Subject: **Docket Nos. 50-361 and 50-362**
Generic Letter 96-06: "Assurance of Equipment Operability and
Containment Integrity During Design-Basis Accident Conditions,"
Additional Information San Onofre Nuclear Generating Station
Units 2 and 3

Reference: Letter from James W. Clifford (NRC) to Harold B. Ray (SCE),
dated August 24, 1998, Subject: Request for Additional
Information Related to GL 96-06 Response for San Onofre 2 and 3
(TAC Nos. M96862 and M96863)

Containment Normal and
Emergency Cooling Units (NCUs & ECUs)

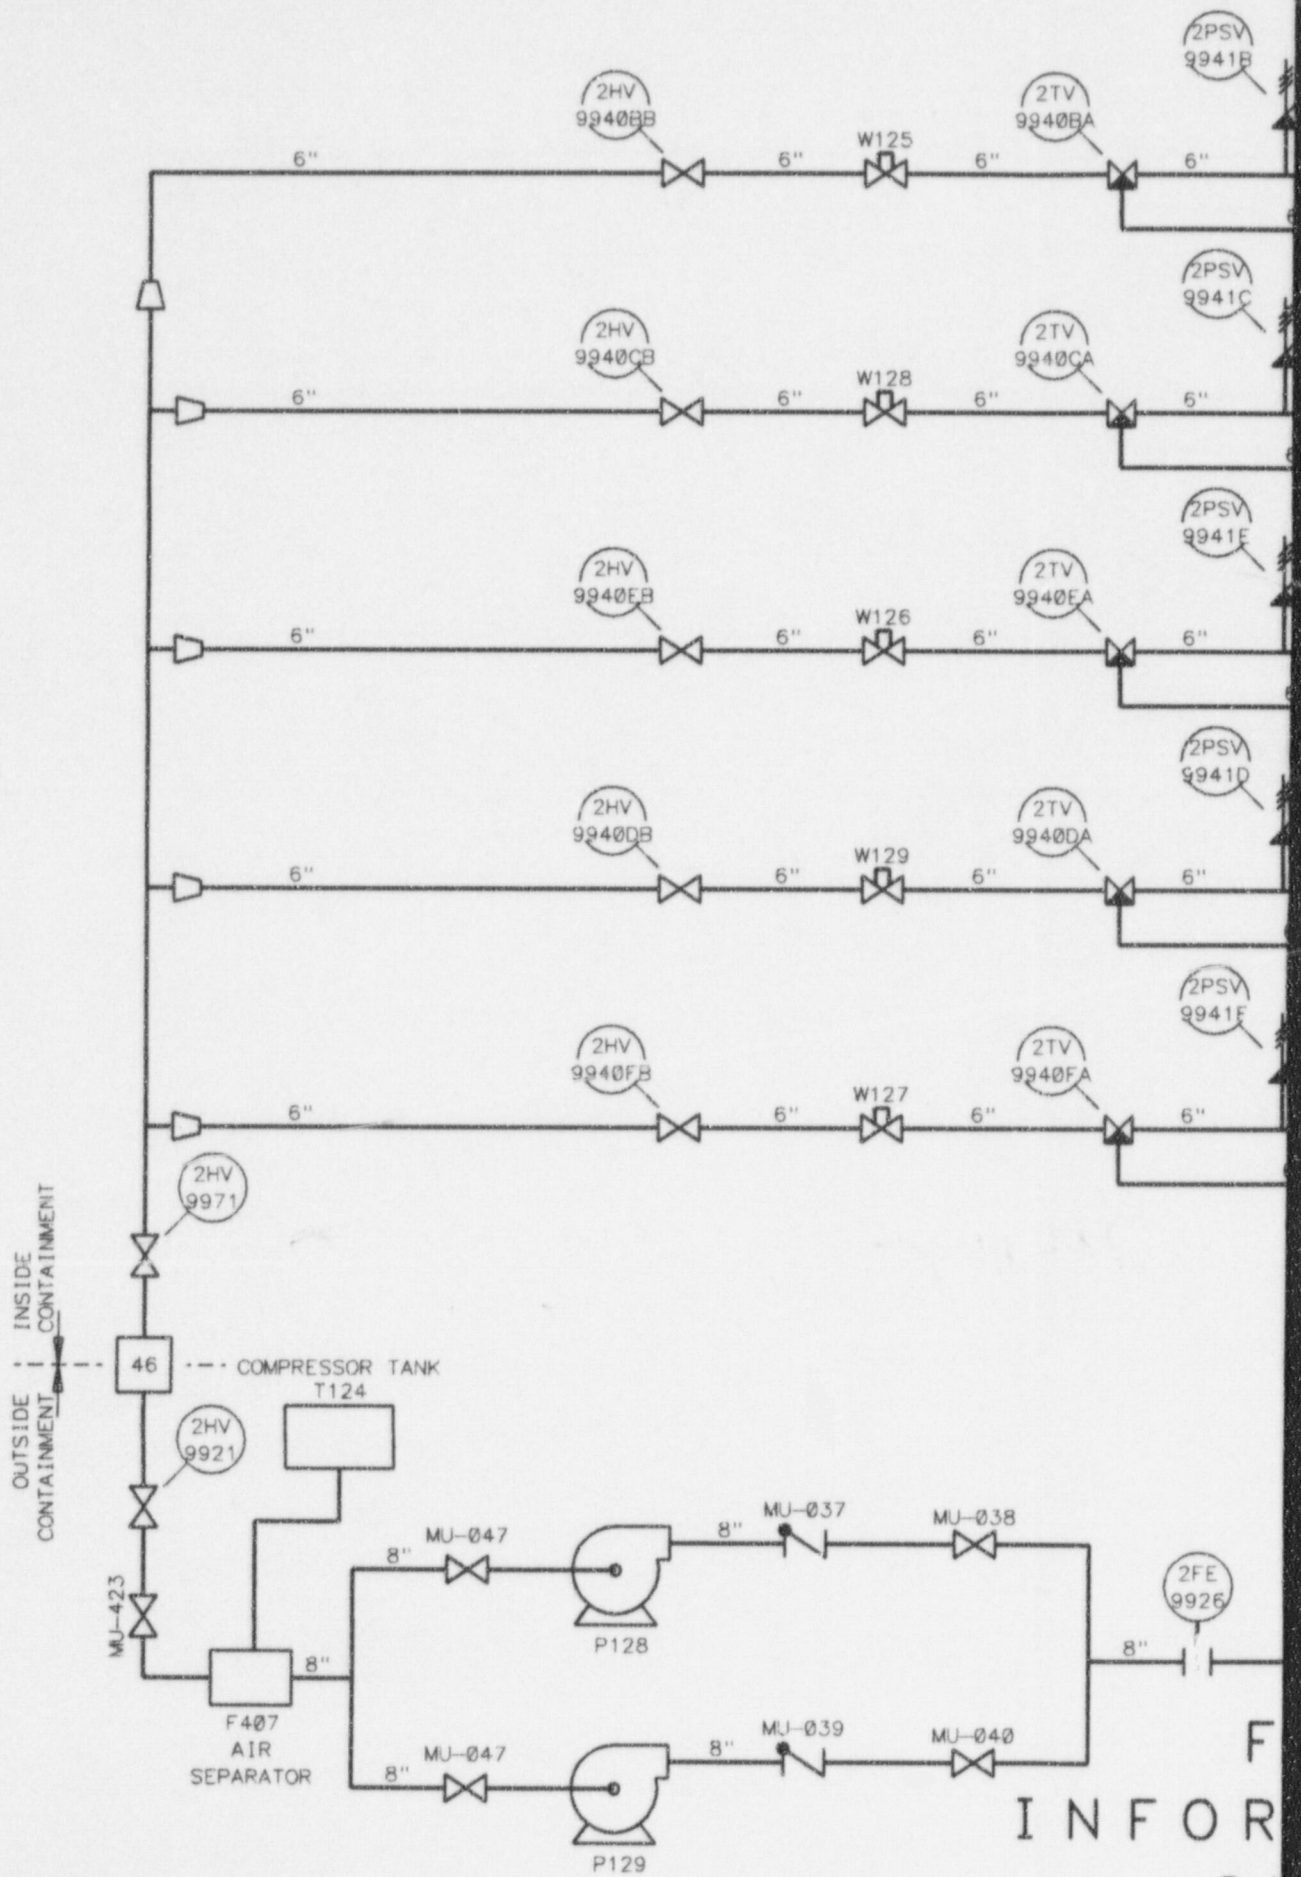
Provide a simplified diagram of the affected portions of the cooling water systems associated with the NCUs and ECUs, showing major components, active components, relative elevations, lengths of piping runs, and the location of any flow orifices and flow restrictions.

Figure 2 shows the cooling water system associated with the NCUs, and Figure 3 shows the CCW system associated with the ECUs. The orifices and other major equipment are shown in these figures. Both Figures 2 and 3 are drawn to scale.

FIGURE 1
 SONGS CONTAINMENT
 NORMAL CHILL WATER SYSTEM

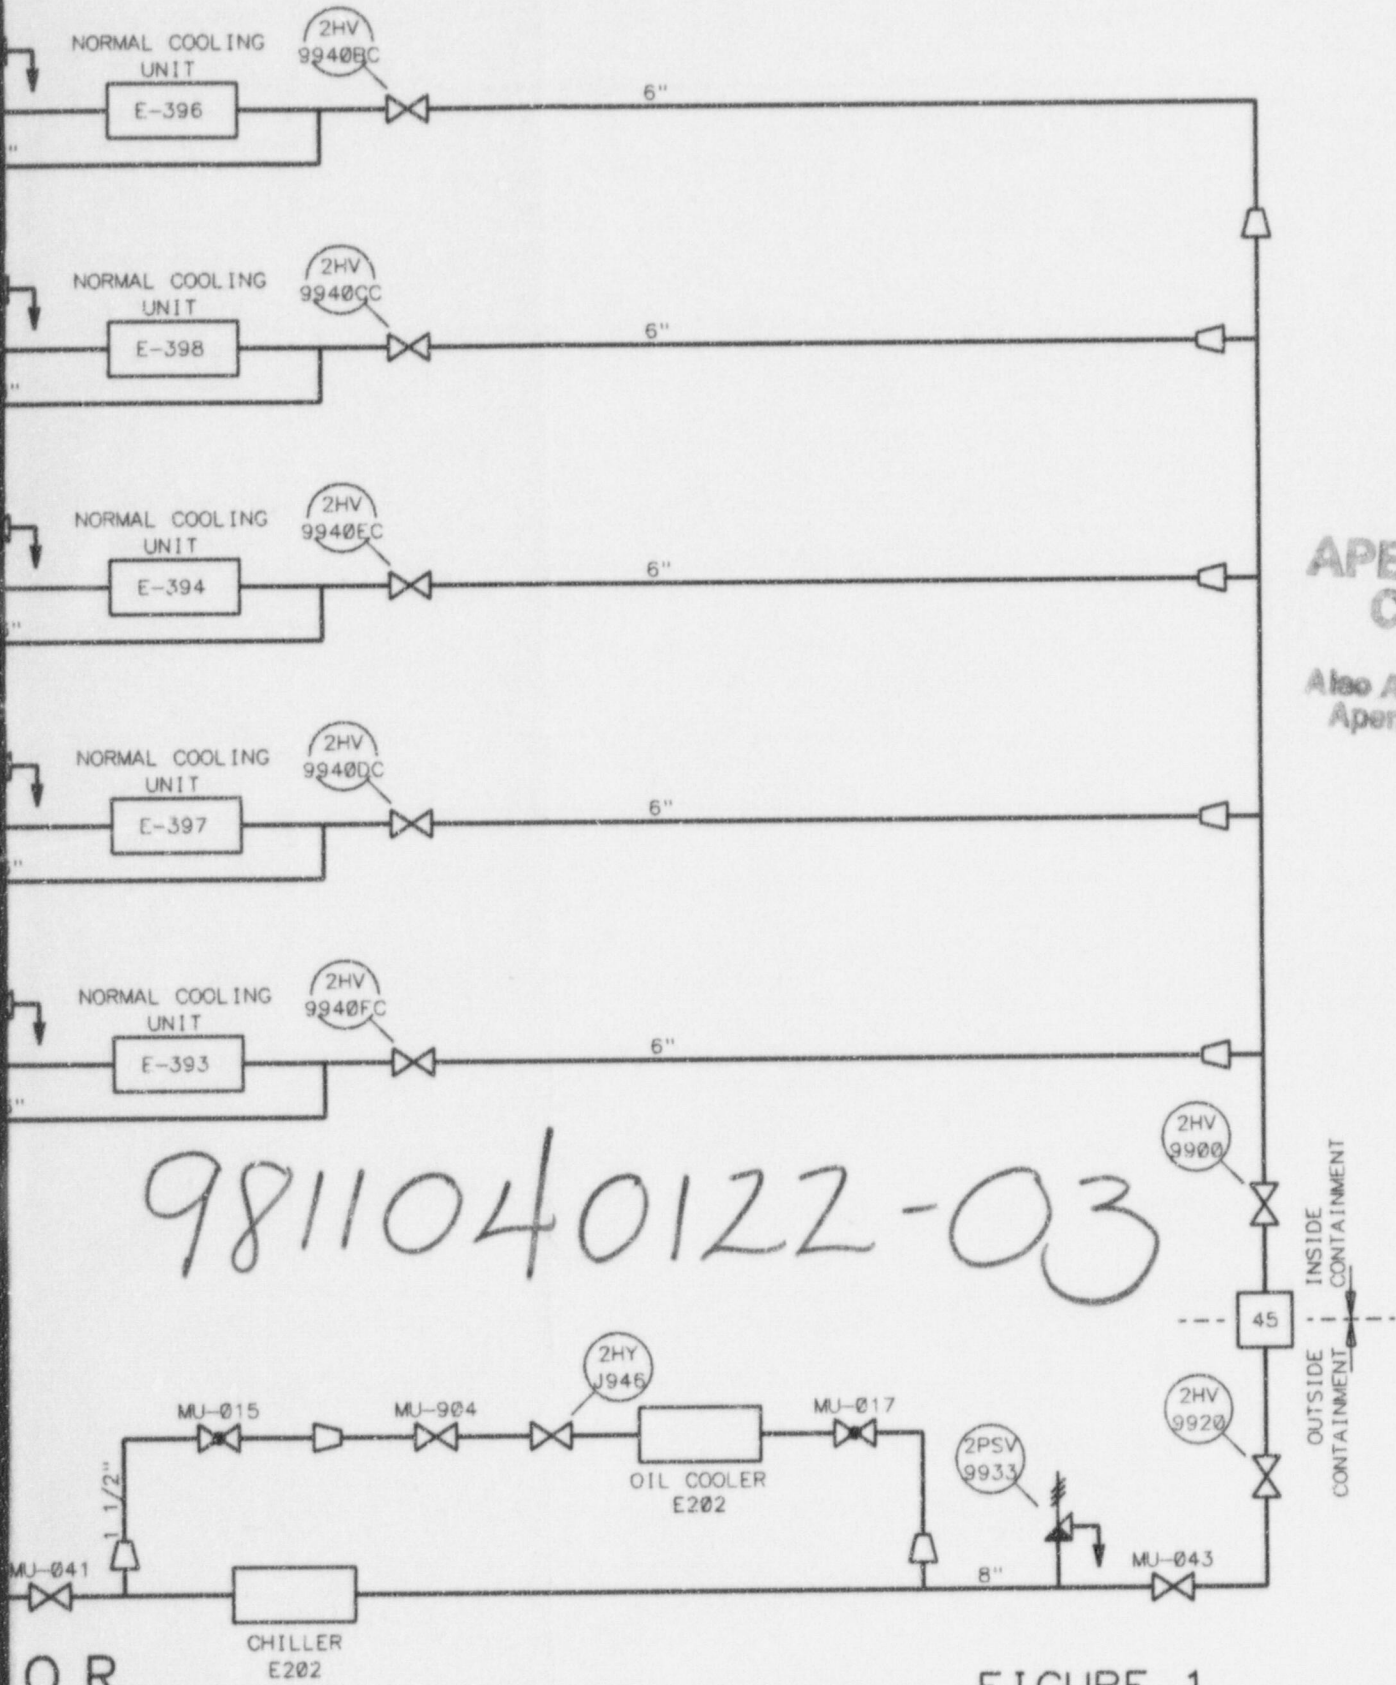
The effects of waterhammer and two phase flow in the NCUs have not been adequately addressed. While the heat removal function may not be required for accident mitigation, containment integrity must be assured. A severe waterhammer in the normal chilled water system could damage containment isolation valves and rupture system piping such that the containment integrity could be violated. Describe measures that exist or will be taken to assure that waterhammer and two phase flow conditions will not occur in the normal chilled water system.

The Containment Chilled Water System is shown schematically in Figure 1. The response is valid for both Units 2 and 3 because the Containment Chilled Water System supplying the NCUs of the two units are identical and independent. The function of the Chilled Water system is to remove the heat from the Containment Normal Cooling Units (NCUs). There are five 25% capacity NCUs that are serviced by the Containment Chilled Water System. Four NCUs operate continuously during normal operation. The chilled water flow rate through the cooling coil is regulated by a 3-way bypass type temperature control valve. The chilled water from the NCUs flows into a return header, having two containment isolation valves (HV-9971, HV-9921). The return header is connected through an air separator to the suction of the chilled water pump. A compression tank is connected to the air separator. Any air that is released from the chilled water is separated from the system by channeling it to the compression tank. Note, the compression tank and its connection to the system piping are located outside the containment. Two 100% capacity chilled water pumps are provided, but normally only one pump is running and one pump is in standby. The discharge of the pump is connected to a chiller unit which removes the heat from the chilled water. The chilled water from the outlet of the chiller flows through a header, having two containment isolation valves (HV-9920, HV-9900), to the inlet side of the coolers.

Referring to Figure 1, the containment isolation valves, HV-9900 and HV-9971 (located inside the containment), are motor operated 8" butterfly valves that close on the Containment Isolation Actuation Signal (CIAS) OR the Safety Injection Actuation Signal (SIAS). These valves are fail AS IS.

The plant Emergency Operating Instructions do not permit opening of the containment isolation valves until the containment pressure and temperature are less than 3.4 psig and 143 F, respectively. Hence, in the event of a postulated accident, such as a LOCA or MSLB, the chilled water system inside the containment will be bottled up between the closed isolation valves located at the inlet and outlet headers. The formation of cavities or boiling of the liquid cannot occur because there is no space to expel the liquid (bounded by the closed isolation valves) and replace it with vapor. The chilled water system inside containment is stagnant and precludes any type of waterhammer or two phase conditions. Pressurization of the liquid (due to thermal effects) between the two containment valves has been dealt with separately in Reference 1. The existing measures are, therefore, sufficient to ensure that there will be no waterhammer or two phase flow in the normal chilled water system.
